20191204 - December's Specifications Committee Meeting

December Specifications Committee Meeting Agenda

Wednesday, December 4, 2019 @ 9:00am

FIGURE 506.6.8.1

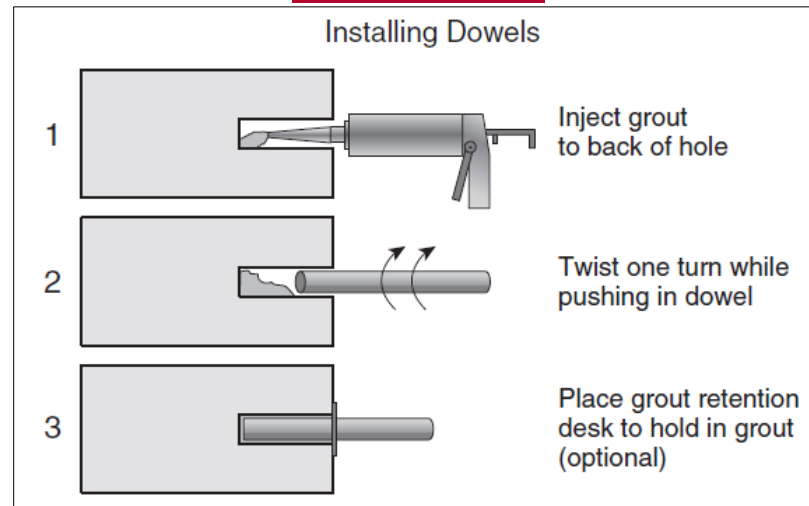
DELETE THE ENTIRE CONTENTS AND REPLACE THE FOLLOWING:

Patching shall consist of full depth, full lane width concrete pavement repairs equal to or greater than ~~6-4~~ feet (~~1.8-1.2~~ meters) in length. Type I patches shall be constructed in accordance with the Concrete Repair Details in the plans.

Patching shall consist of partial depth concrete pavement repairs that extend a minimum of 2 inches (50mm) and no deeper than one-half the slab thickness at cracks or no more than one-third the slab thickness at doweled joints. Type II patches shall be constructed in accordance with the Concrete Repair Details in the plans.

Patching shall consist of a repair along the edge of a transverse crack or joint that extends from the bottom of a partial depth repair (Type II) to potentially the full depth of the slab, and isolated within 12" of either the longitudinal joint or pavement edge. Type III patches shall be constructed in accordance with the Concrete Repair Details in the plans.

inch (230 mm) length, the repair boundary shall be re-sawed 1 foot (300 mm) back from the existing repair boundary, and dowels shall be re-installed. This work shall be done at the Contractor's expense.

The surface edges of all patches shall be tooled, formed and/or sawed, and cleaned to result in a properly dimensioned reservoir for sealant. All transverse and longitudinal joints at pavement repair locations shall be sealed in accordance with manufacturer's recommendations unless otherwise approved by the Engineer.
